## ROAD SAFETY AUDIT REPORT

### SR-5/SR-A1A/US-1 (BROADWAY AVENUE) FROM 45<sup>TH</sup> STREET TO 59<sup>TH</sup> STREET

Safety Review FM No. 429650-2-32-01

August 2019

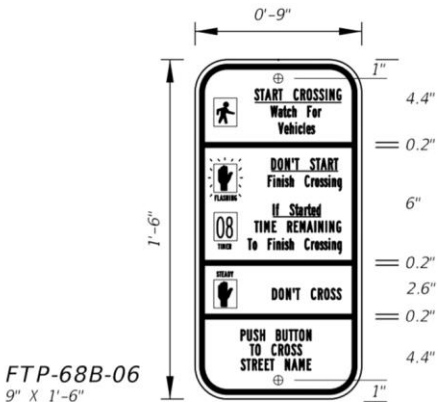
ID	Location Description:	Spot Observation Overview:	Recommendations:
02	SR-5/SR-A1A/US-1 (Broadway Avenue) at 54th Street	Standard crosswalk markings	Upgrade to Special Emphasis Crosswalk markings

Crosswalk markings on north and south legs of this intersection are standard type and in poor condition.

Retrofit crosswalk markings to Special Emphasis on north and south legs. Restripe crosswalk borders along areas with pavers on east and west legs.

Details of Special Emphasis markings are included in FDOT Standard Plans Index 711-001.

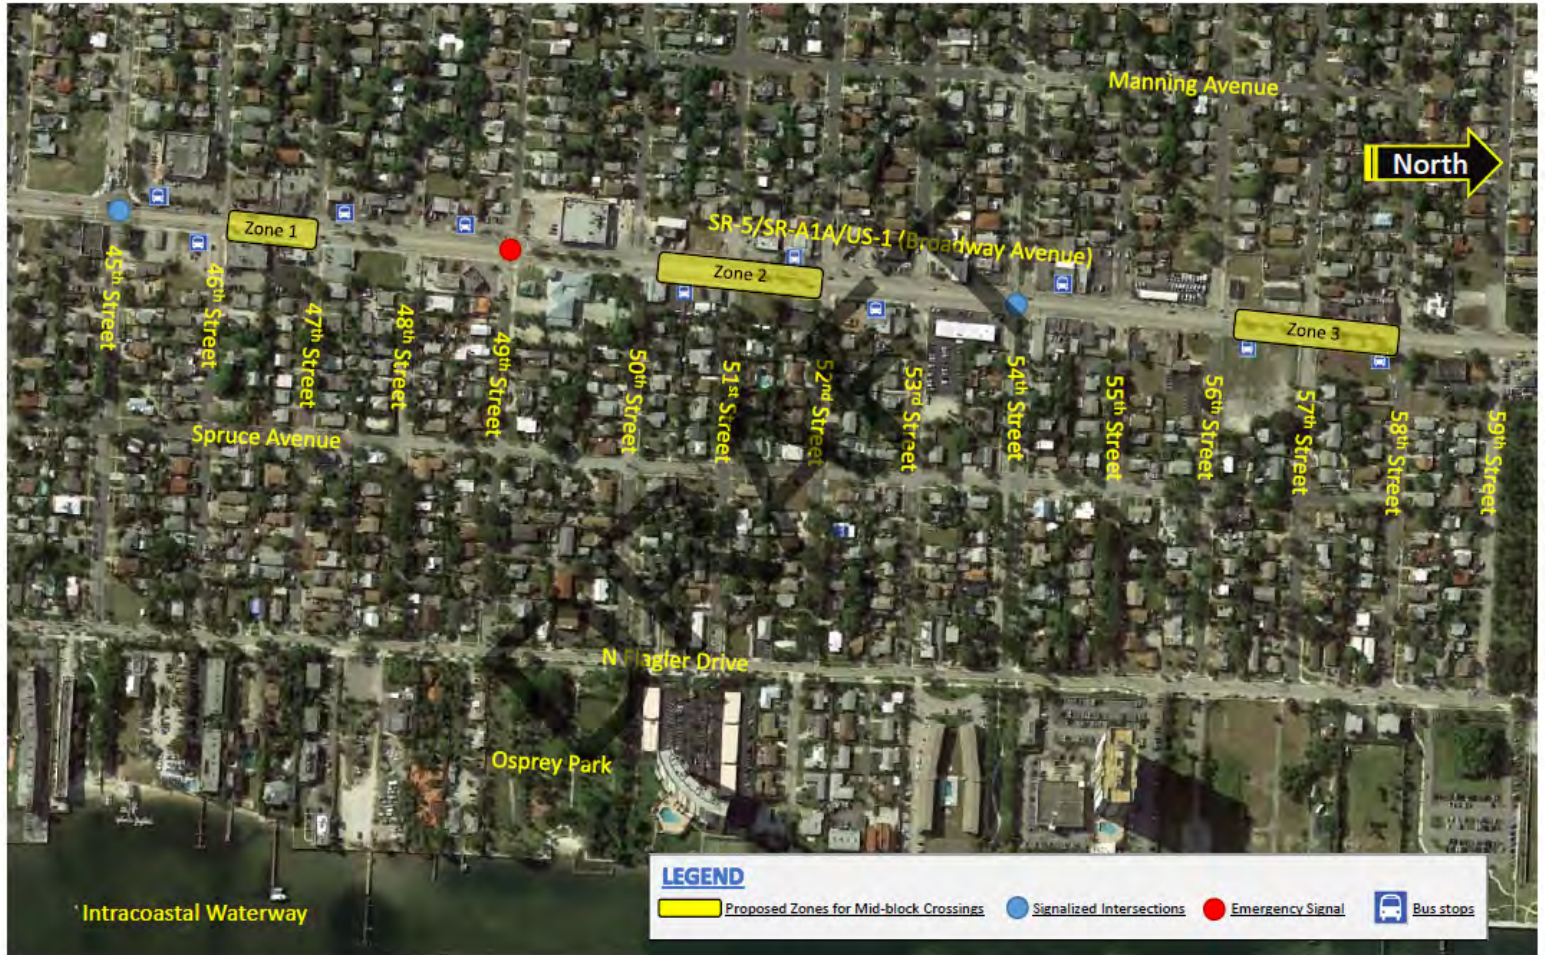
Yesterday's meeting was attended by Tara Applebaum (VZ coordinator) and Lt. Bevell. From FDOT, we had Tracey, Tom, David, and (I didn't get PE Trainee's name, was it Silvia). I did send Tara the draft report as you requested.

- Initiate 3-day crossing counts:
  - Zone 1 between 46<sup>th</sup> and 48<sup>th</sup> (one block north of what the image shows)
  - Zone 2 between 50<sup>th</sup> and 52<sup>nd</sup>

- Zone 3 between 56<sup>th</sup> and 58<sup>th</sup>
  - I would like the counts to be presented on an aerial showing the actual location of the crossings and note the number of children and elderly/disabled. I can send a sample if needed.
